# Town of Knightdale

## Staff Report

Title: Old Faison Place Planned Unit Development (ZMA-1-24)

Date: March 20, 2025

### Old Faison Place Proposed Master Plan

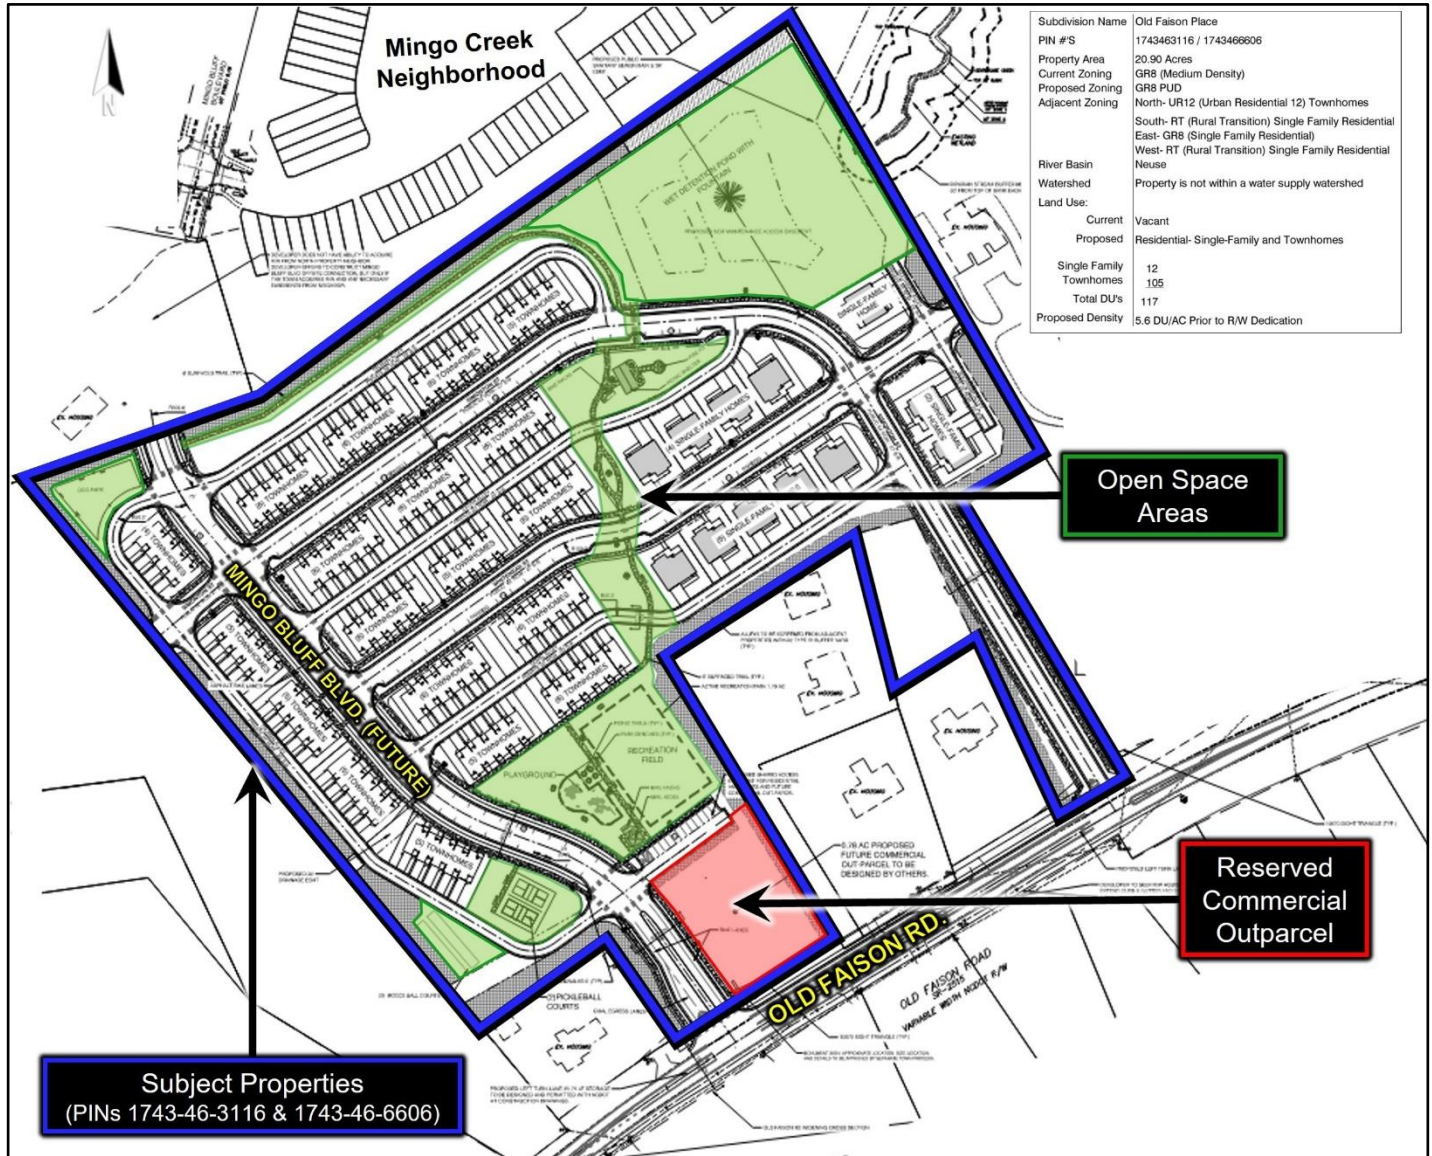
Staff have reviewed the plan for UDO consistency and found the Master Plan is generally compliant with the required provisions. However, further modifications to the Master Plan are required as noted herein. The following items are being highlighted for Council review and further consideration.

#### **Landscaping & Tree Preservation**

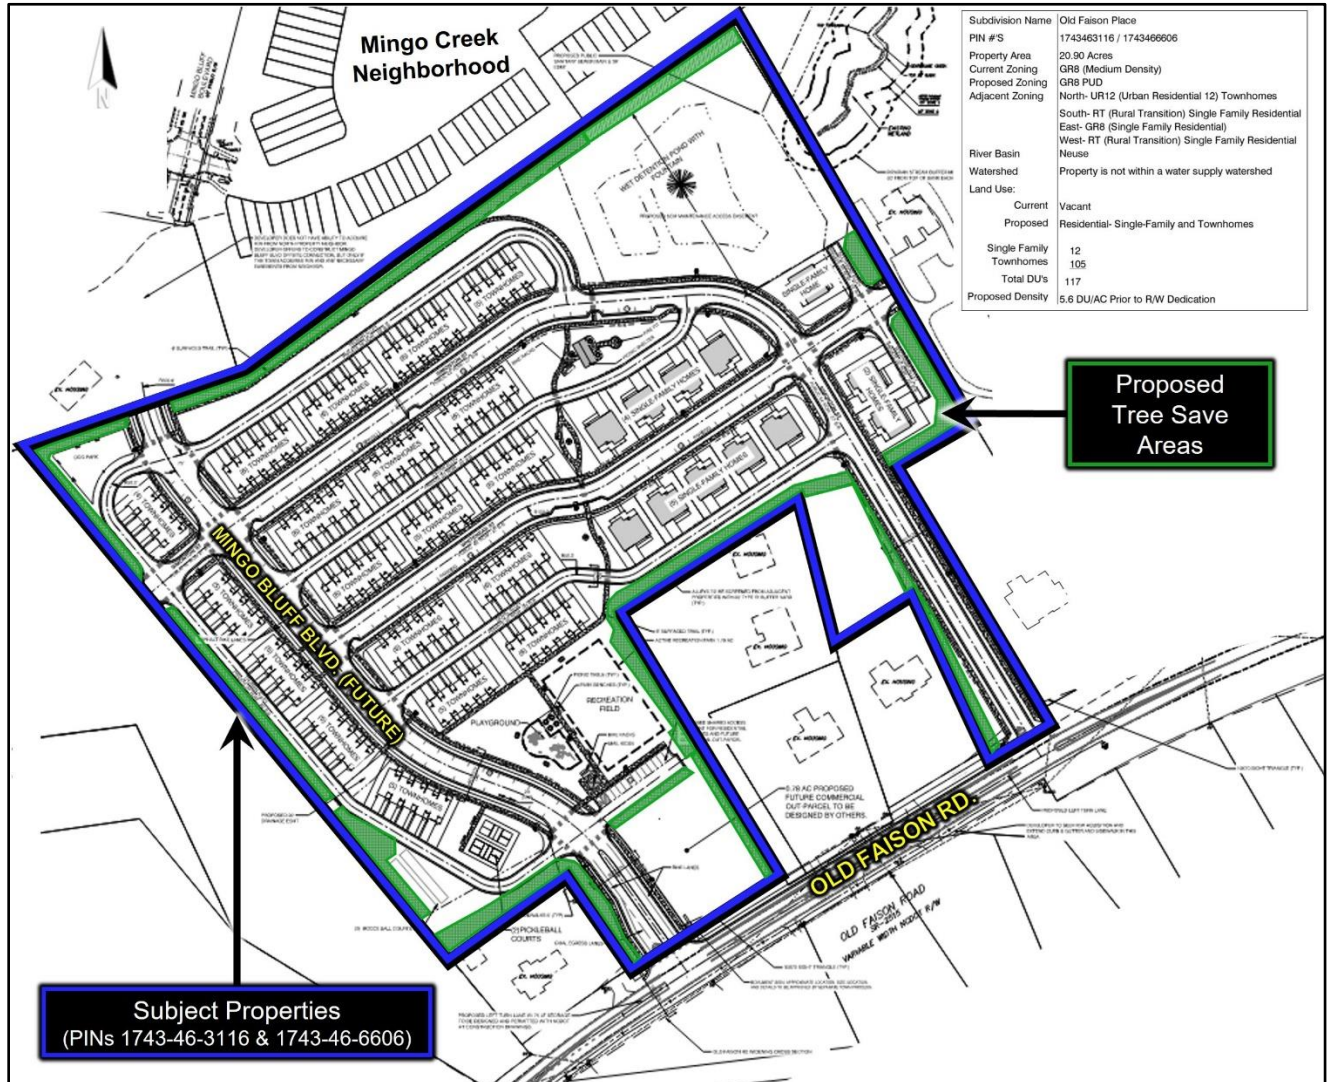
The Applicant has demonstrated general compliance with the Buffer Yard and Screening requirements across the entire site. As proposed, a 20-foot Type B Buffer, made up of existing vegetation and supplemented with new plantings where necessary, will remain around the perimeter of the site. The 20-foot Type B Buffer will also serve as screening for alleys and other infrastructure along the perimeter of the subject properties. At the Neighborhood

Meeting, there were concerns about the impact of the new roadways on adjacent properties, specifically the three properties between the two proposed neighborhood entrances and the two properties on either side of said entrances. *Staff recommend that the Applicant continue discussions with these neighbors and propose a solution that lessens the impact of the new roadways and that is amenable to all parties.*

Based on preliminary calculations, a tree cover area of 10% of the site (~2.1 acres) is required. These areas of preserved tree cover are generally around the perimeter of the subject properties. *Although general compliance with this regulation has been demonstrated, Staff recommend that the Applicant continue to look for ways to preserve more existing tree canopy through construction. Staff also recommend that larger diameter street trees are planted as the roadways are constructed throughout the development.*

### Open Spaces

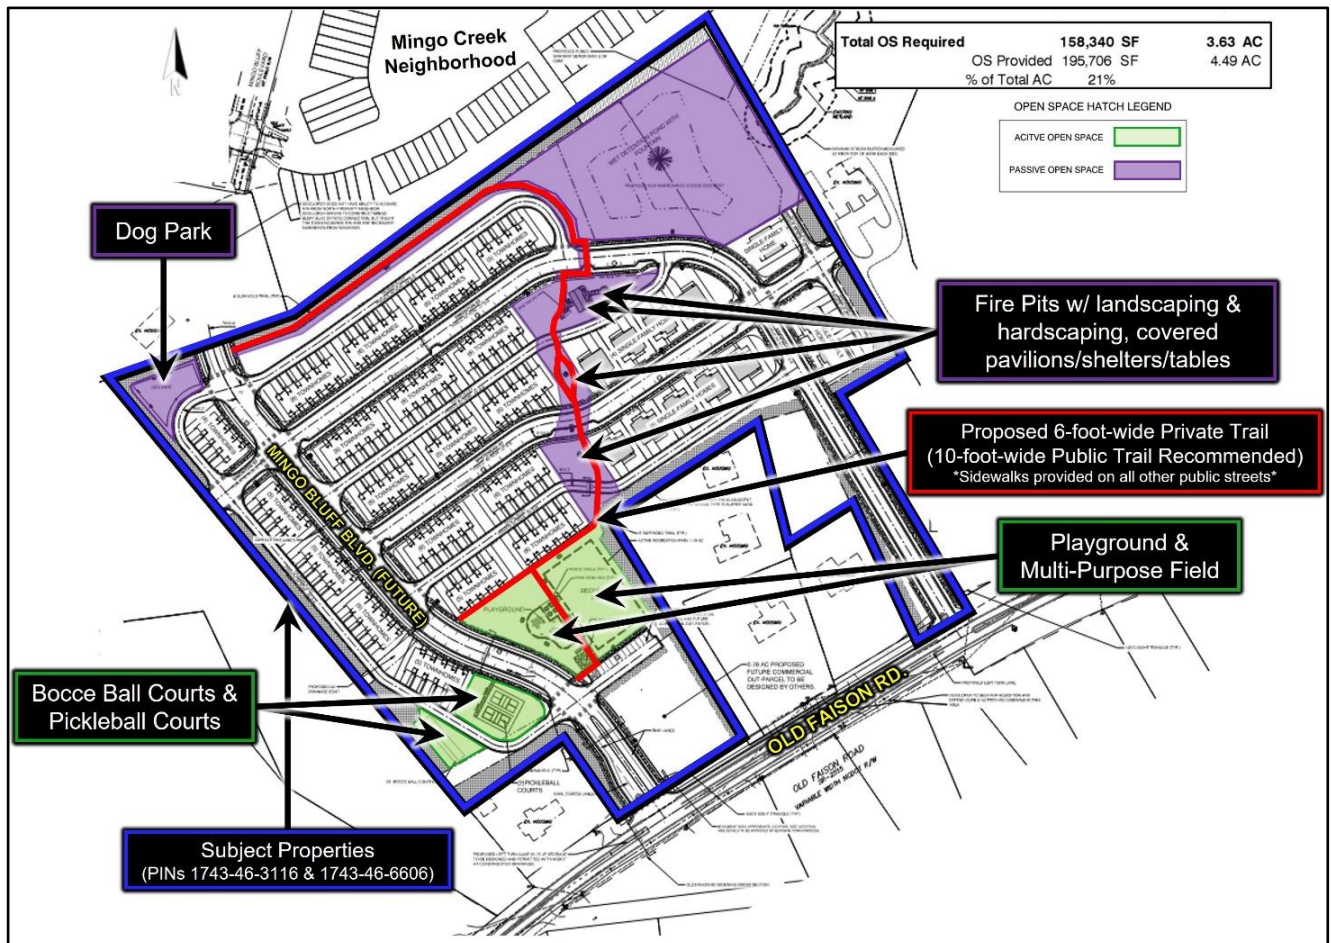
from the Environmental and Creative categories. *Staff recommend that the Applicant update their PUD Document to include example imagery of these recreational open space elements to demonstrate the quality of the proposed amenities. In addition, Staff recommend that the SCM is amenitized to meet the intent of passive open spaces.*

The Applicant has illustrated the general location of all active and passive open spaces on the Master Plan and has demonstrated that there is sufficient land area to accommodate the required recreational areas; however, further definition of the proposed recreation elements within each open space area are necessary to comply with the Section 11.2.B.7 of the UDO. *Additional detail on how the open spaces will be programmed is also recommended by Staff.*

### Pedestrian Connectivity

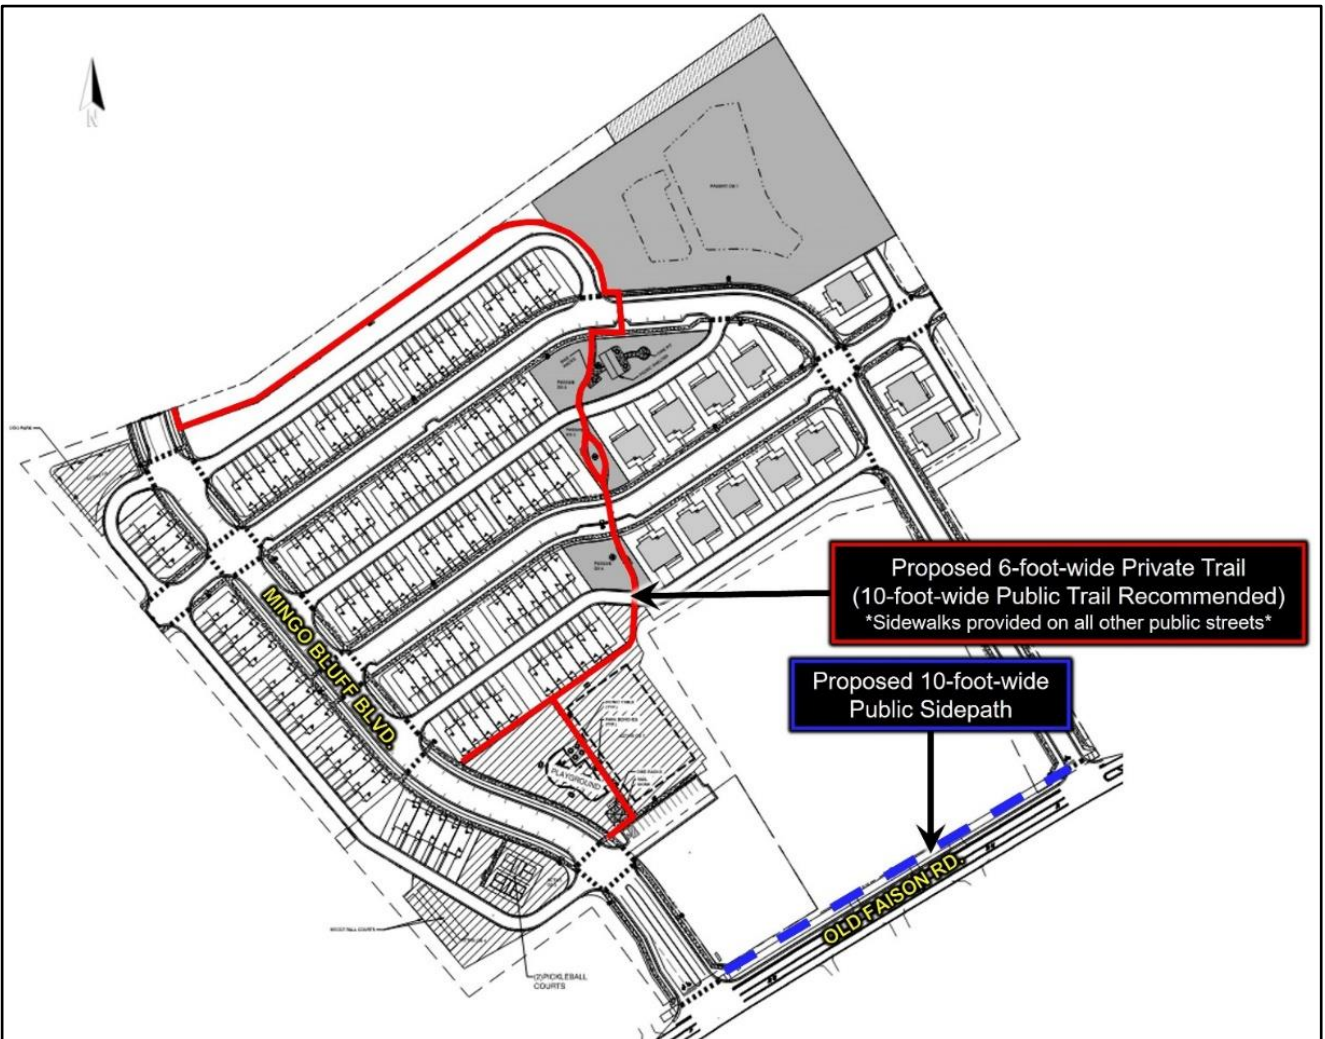
The Applicant proposes a residential neighborhood with 5- and 6-foot-wide sidewalks along all public roads, except for Mingo Bluff Boulevard extension, which will be built to the Urban Main Street (Wide Sidewalk) roadway cross-section standard with a 10-foot-wide sidewalk on both sides. In addition, the Applicant proposes a 6-foot-wide private trail that meanders through the subject site. *Staff recommend that this corridor is increased to 10 feet to align with the UDO, which requires both public and private trails to be 10-foot wide and paved.*

### D. Street Network Map

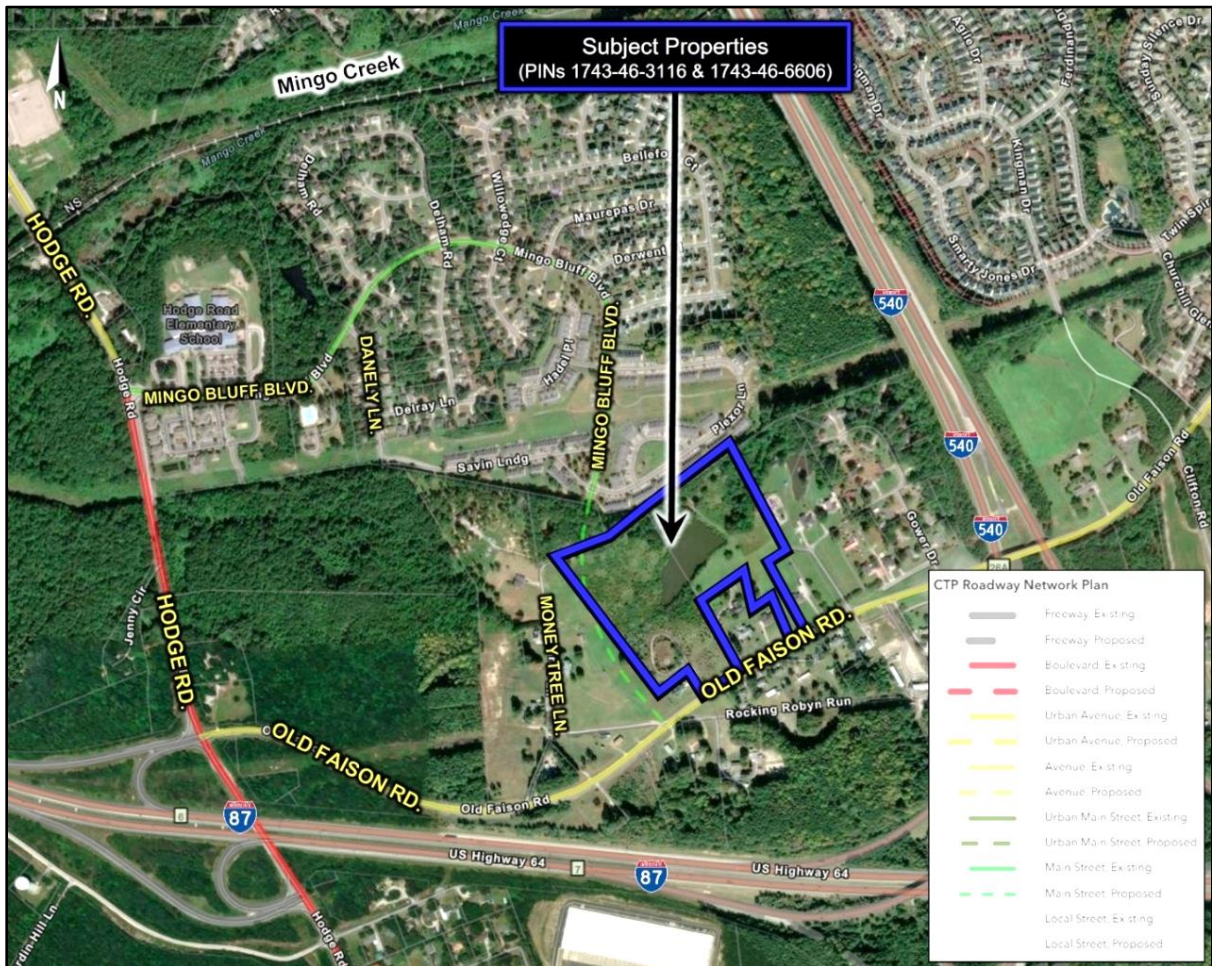
Development activities should assist with the construction of a comprehensive transportation network. The proposed development will construct the portion of Mingo Bluff Boulevard, which will eventually connect Old Faison Road to Hodge Road through the Mingo Creek subdivision. However, there is an intervening parcel between the subject properties and the existing Mingo Bluff Boulevard within the Mingo Creek subdivision that reduces the viability of making this roadway connection through construction of this proposed project.

Staff encourage the Applicant to continue conversations with the adjacent neighbors and look for ways to acquire the necessary land area to make this roadway connection between the existing Mingo Creek neighborhood and the proposed development. Staff also recommend the Applicant is prepared to discuss the measures taken to acquire said land area.

Although this roadway connection is identified as a Main Street on the Comprehensive Transportation Plan (CTP), Staff determined that an Urban Main Street (Wide Sidewalk) would be an appropriate deviation in design, largely based upon the fact that townhomes are the predominant housing types proposed with this development (see requested Site Development Allowance on Pages 15-17 of this Staff Report). If approved, this design change from a Main Street to an Urban Main Street could result in an additional thirty on-street parking spaces being added for residents and visitors of the neighborhood. The differences in design are shown on the next page.
